LOTTE DAM
WAYNE COUNTY, MISSOURI
MISSOURI INVENTORY NO. 30309

PHASE I INSPECTION REPORT
NATIONAL DAM SAFETY PROGRAM

PREPARED BY: ST. LOUIS DISTRICT CORPS OF ENGINEERS
FOR: GOVERNOR OF MISSOURI

AUGUST 1979

LOTTER'S LAKE
 DAM PLAN VIEW
 PLATE 3

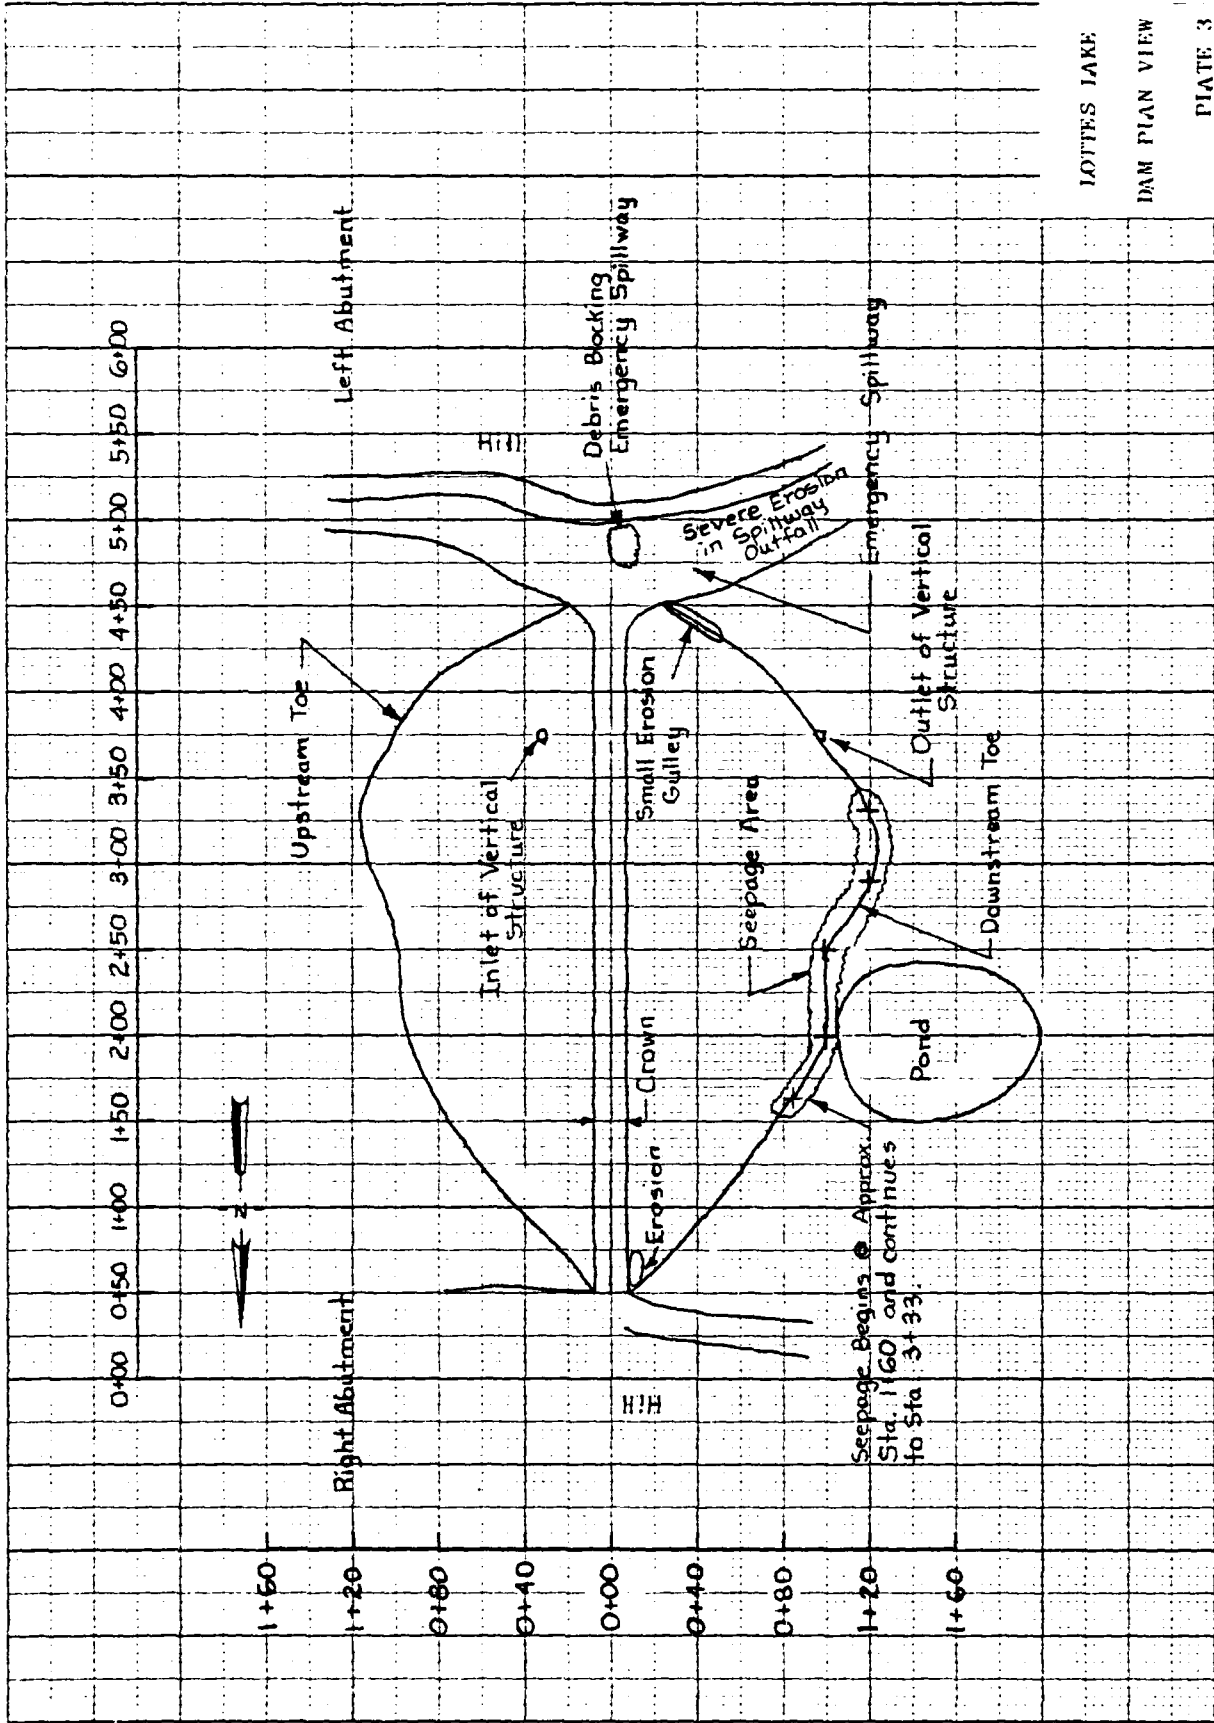
Seepage was observed flowing from several locations at the toe of the dam from Sta. 1+60 to Sta. 3+33 (see Plate 3). There was also slight seepage flowing from the right abutment. Seepage was estimated to be approximately 5 gpm from each of the locations except at Sta. 2+90 where the seepage was estimated to be 20 gpm. All of the seep water, except that flowing from the right abutment, was reddish in color, indicating flow through a high iron content soil. None of the seepage appeared to be piping any material from the embankment or foundation. Seepage from the right abutment and at approximate Sta. 2+00 was used to feed a pond constructed at the toe of the dam near the right abutment (see Plate 3 and Photo 14). The pond is used to water stock and as a minnow pond. The pond follows the toe of the dam for approximately 75 feet and extended approximately 100 feet perpendicular to the dam. According to the owner the seepage began after the construction of the dam, but it has decreased approximately 80% during the life of the dam.

- (4) The downstream slope and toe should be closely monitored for seepage and erosion. If seepage quantities and/or erosion observed during monitoring indicate increases or signs of material being piped from the embankment, immediate action should be taken to rectify these conditions.
